Response To Comments and Revised Site Investigation Work Plan

10151 International Blvd, Oakland, California

Fuel Leak Case No.: RO0002444

Union Oil Station No. 7124
10151 International Boulevard
Oakland, California

UNION OIL STATION NO. 7124 10151 INTERNATIONAL BOULEVARD OAKLAND, CALIFORNIA	
SITE PLAN WITH PROPOSED CPT LOCATIONS	
	FIGURE 3

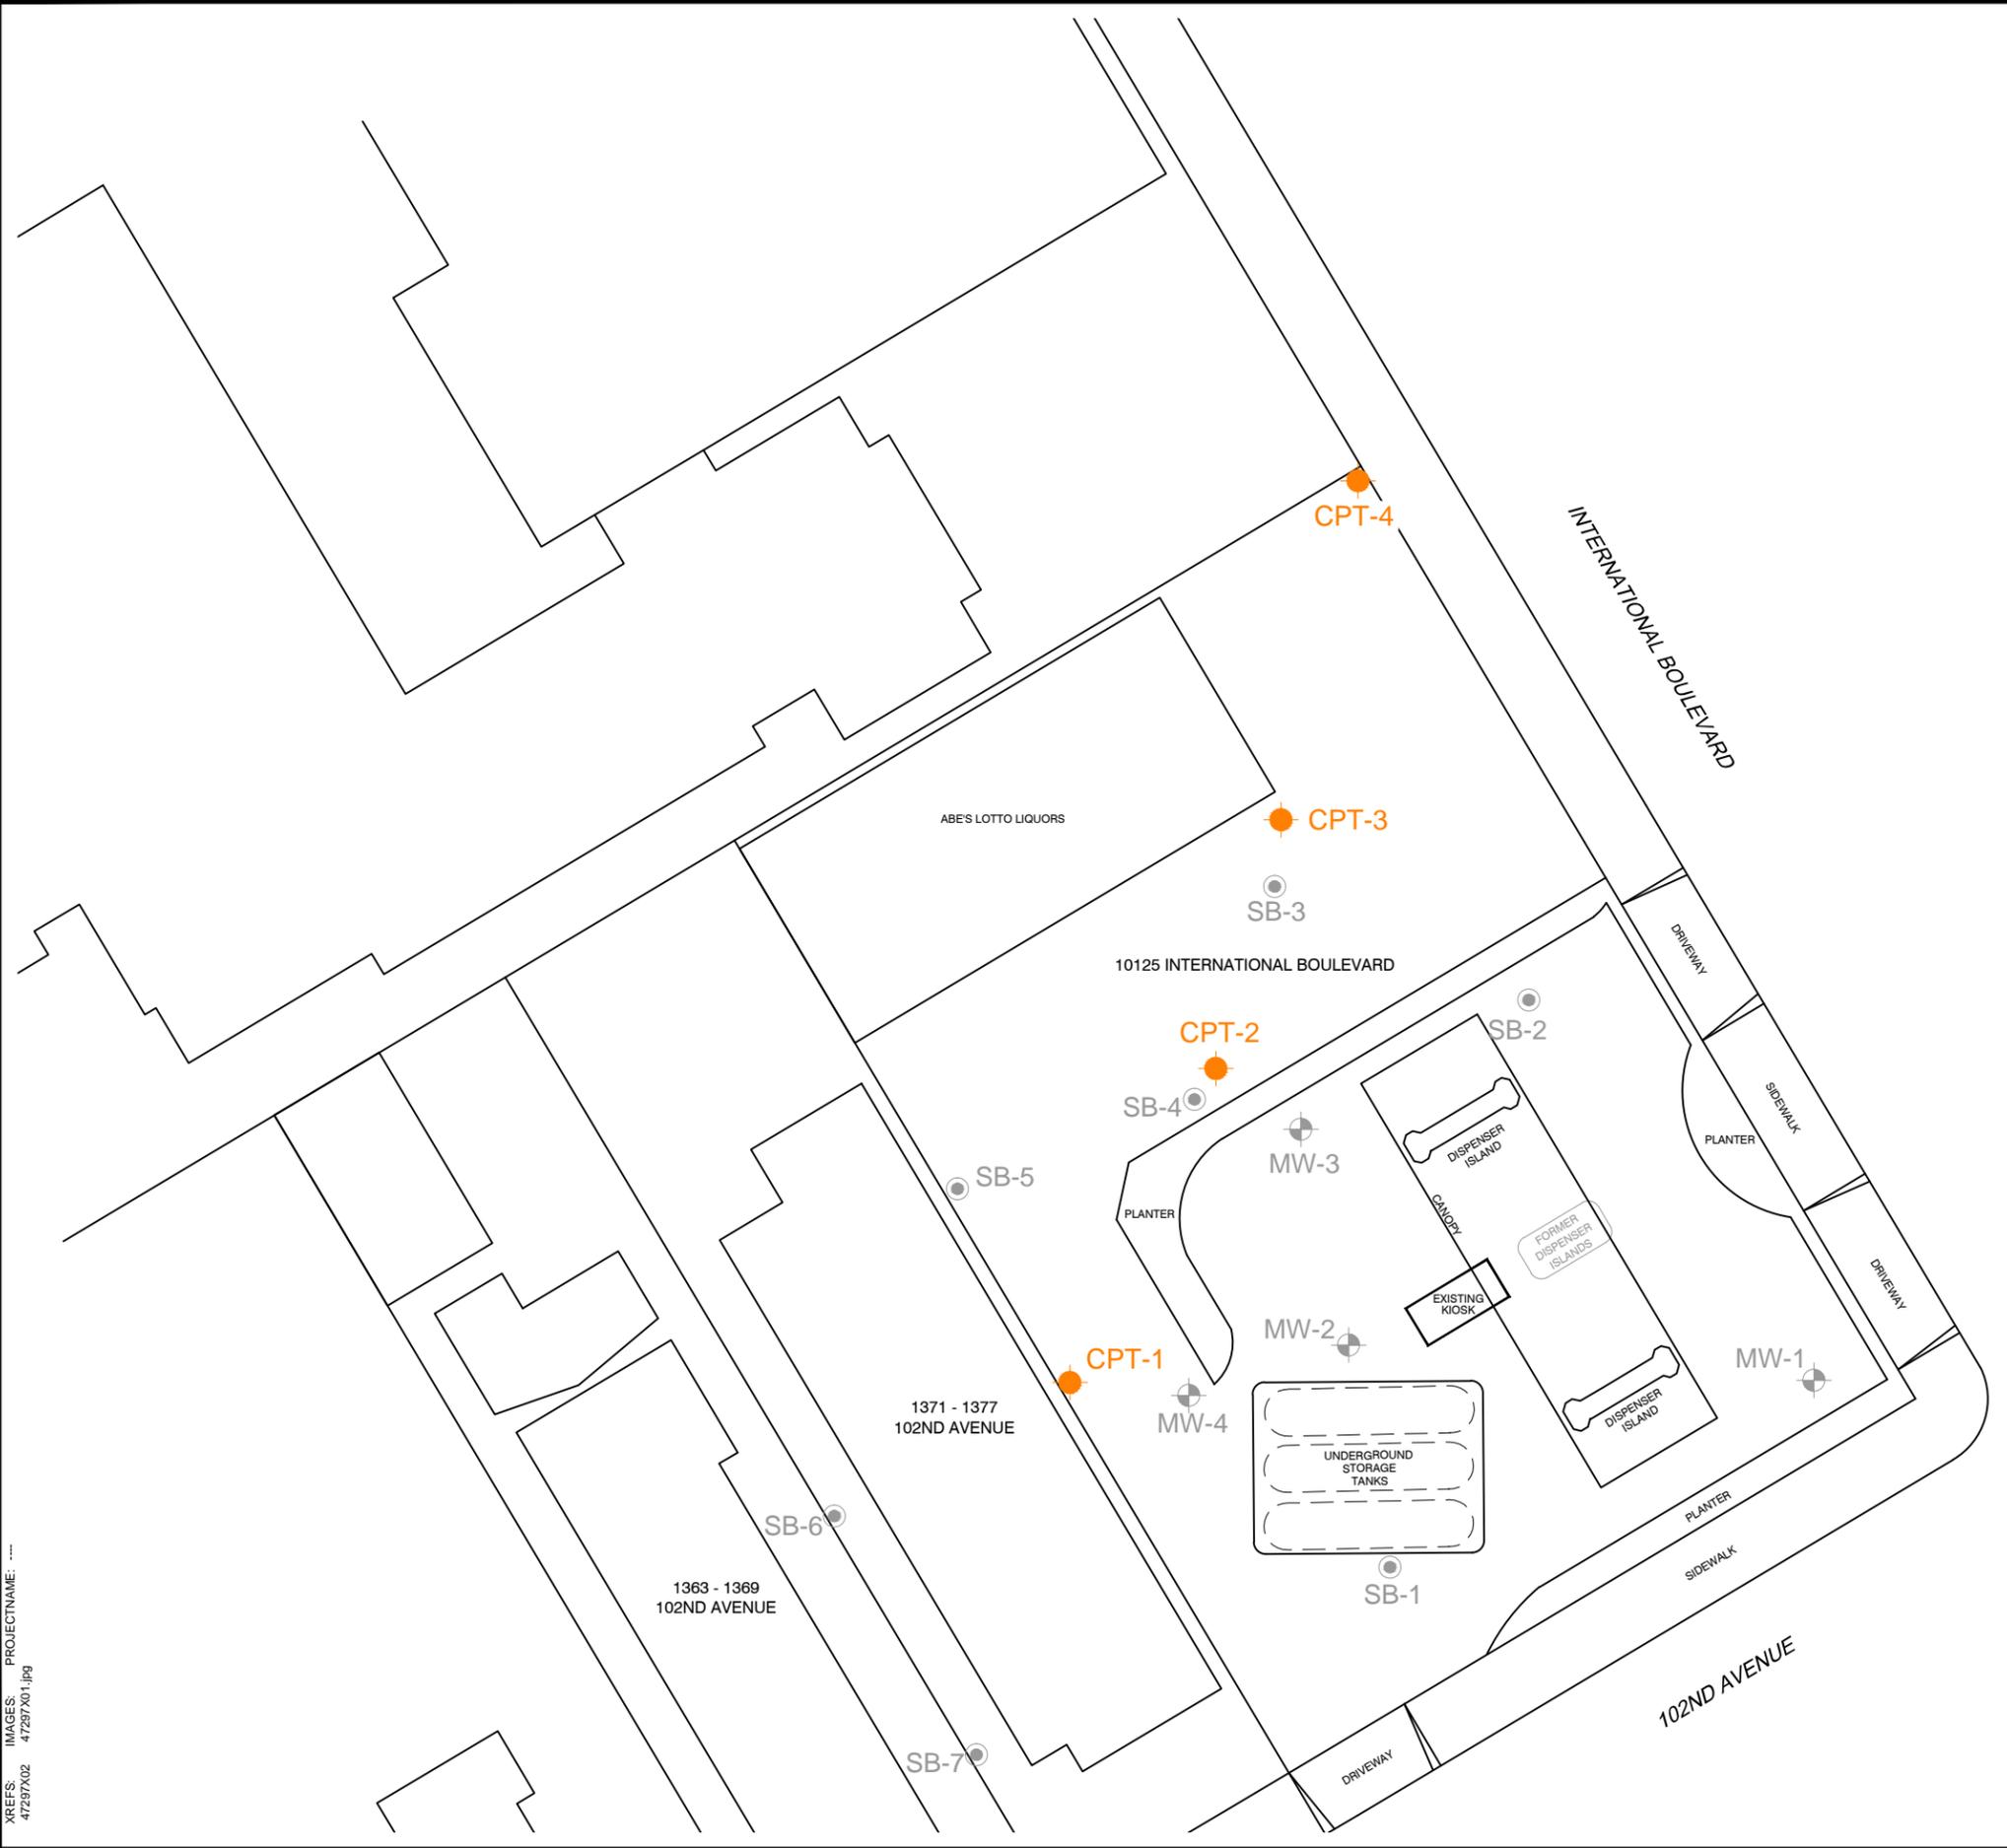
“Historic groundwater suggests a predominately western flow direction; however the proposed locations are to the north of the site and therefore fail to adequately delineate the plume. No justification has been provided to support the proposed well locations.”

- f. Historic groundwater data suggests a predominantly western flow direction; however, the proposed locations are to the north of the site and therefore fail to adequately delineate the plume. No justification has been provided to support the proposed well locations.

Historical groundwater has fluctuated from north to west with a few instances of a southern flow observed. However, more recent data suggests a predominantly north to northwest flow direction, leading to the investigation being aimed in that direction. Furthermore, multiple residences to the northwest and west limit areas to conduct an investigation to the west. However, as shown on Figure 3, one CPT location (CPT-1) is proposed near the west-northwest site property line, as well as locations to the north to ensure the site is adequately delineated.

In order to delineate soil and groundwater, ARCADIS proposes to advance four CPT locations (CPT-1 to CPT-4) as shown on Figure 3. The locations may be modified in the field based on encountered obstructions (e.g.; overhead and/or underground utilities).

ARCADIS will collect a grab groundwater sample at each proposed CPT location (Figure 3). The grab groundwater sample will be collected in order to assess the elevated concentration of TPH-g detected in the grab groundwater sample from SB-4 in 2008. ARCADIS will collect the groundwater sample for analysis with a disposable Teflon® bailer decanted into the appropriate laboratory-supplied containers. ARCADIS will place the sample on ice, where it will be cooled to approximately 4 °C and transported to a State of California-certified laboratory under chain-of-custody documentation. The grab groundwater sample collected will be analyzed for the following:
